**Robatel Technologies Responses to the
NRC Second Round of Request for Additional Information
for the
Model N° RT-100 Package
Docket N° 71-9365**

The NRC Request for Additional Information (RAI) identifies information needed by the staff with regard to its review of the Robatel Technologies Safety Analysis Report, Revision N°2, dated September 18, 2013. The RAI questions are grouped by chapter number and title from the Safety Analysis Report, along with the Robatel Technologies Response. The response addresses the question where applicable, references the locations in the SAR and/or supporting documents where revised information can be located.

Figure 1- Upper Impact Limiter Dose Rate Response for Co-60

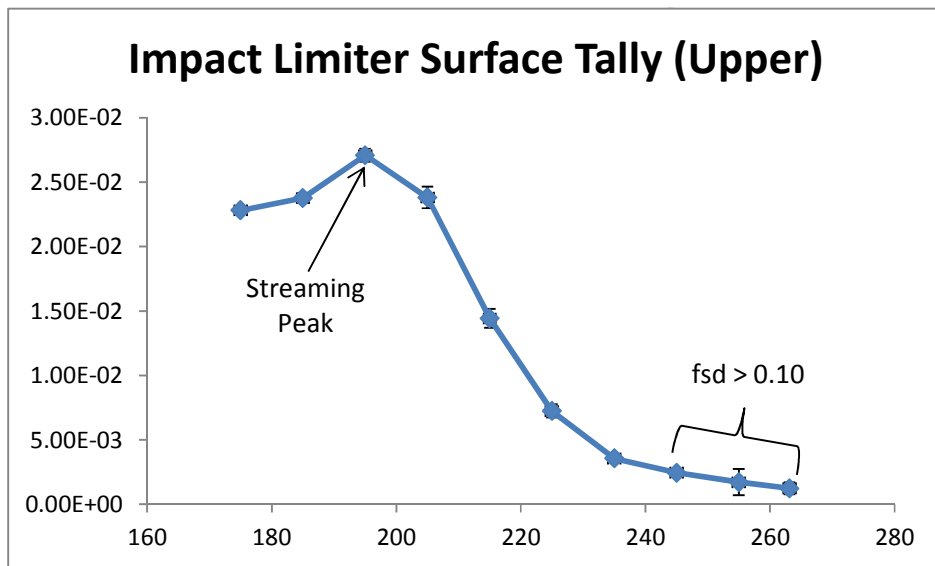
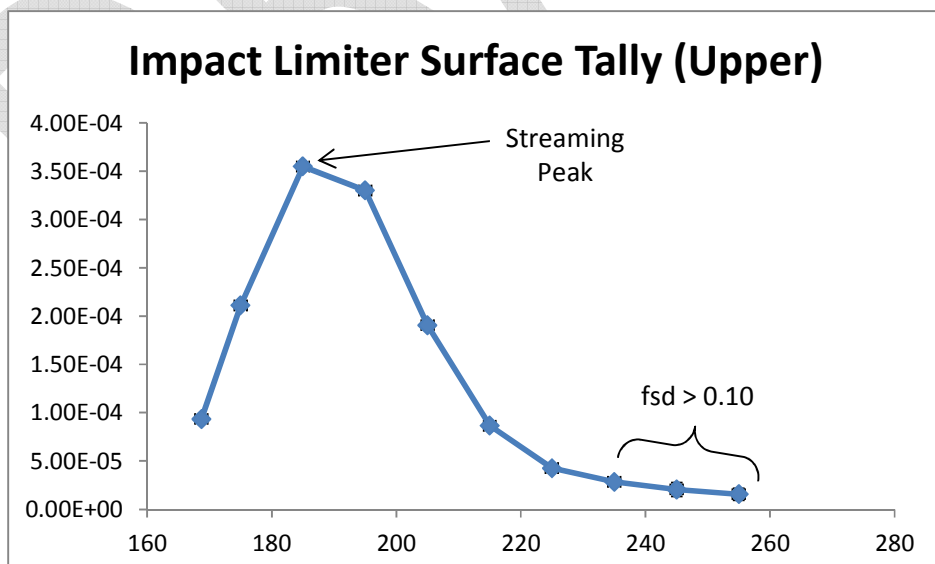
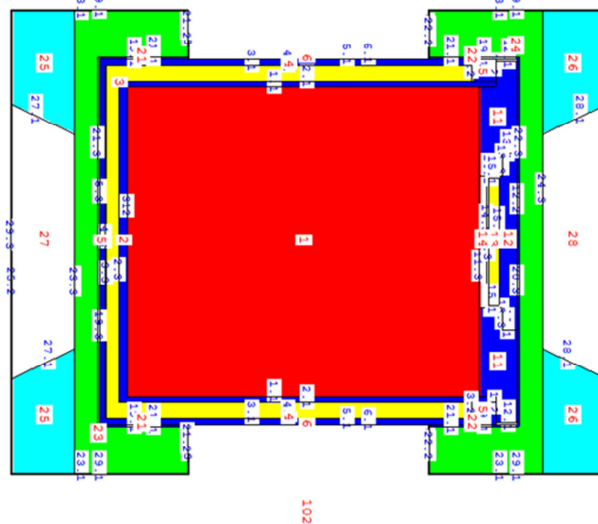
Demonstrate that the response method used is accurate and reliable with focus on mid- and low-energy particles and prove that all MCNP shielding calculations have converged properly.

In addition, the staff's confirmatory calculations using the applicant's models indicated that most of the low mid-to-low energy particle MCNP calculations do not converge with the time specified in the models and the applicant confirmed this during a meeting. Hence, the results presented to the NRC in the application might have been erroneous and misleading. The applicant needs to provide results that are accurate and reliable.

The dose rate response for the upper impact limiter for Co-60 is plotted in Figure 1. From Figure 1 it is clear that the peak dose rate locations are captured by the tally, and the upper end of the upper impact limiter does not contain a peak location. This same figure is presented for Cs-137 in Figure 2. The same conclusions can be drawn.

Figure 8.1.4-5. Test Apparatus for Measuring the Helium Leak Rate through the Quick Disconnect Valve Cover Plate

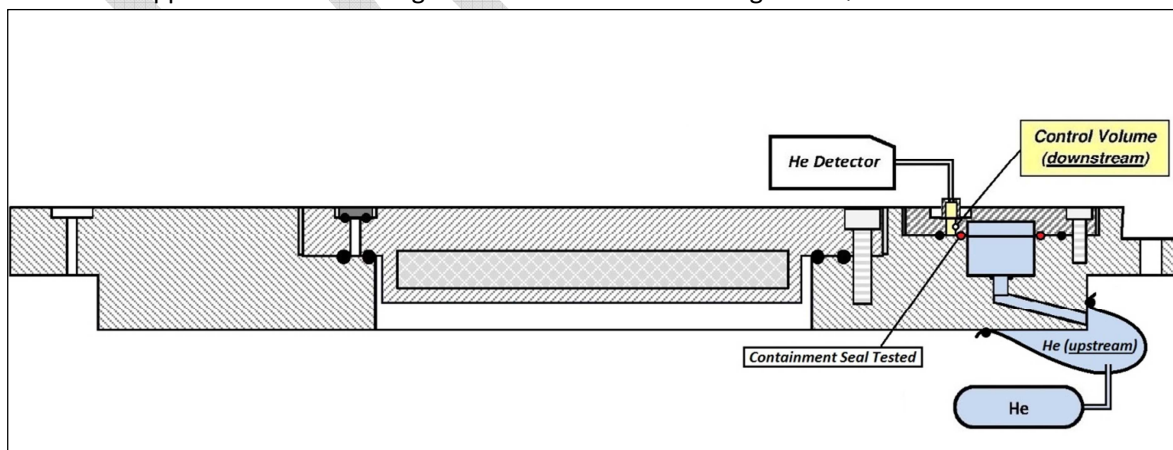
Clarify the quick disconnect valve and quick disconnect valve cover plate leakage test procedures.

The quick-disconnect valve and its cover plate can be tested either with the primary lid off or on the cask body. In the first configuration with the primary lid off, a bag containing helium is attached to the lower portion of the primary lid. In the alternate configuration with the primary lid on, the secondary lid is removed, covered with plastic sheet and taped, and the opening is used to inject helium into the cask cavity. The only difference in the configurations is how the helium is injected. The containment boundary and the test method are identical. Sections 8.1.4.3 and 8.1.4.4 have been updated to include figures to show the test configurations. Figures 8.1.4-5 and 8.1.4-6 from the SAR have been provided below for reference.
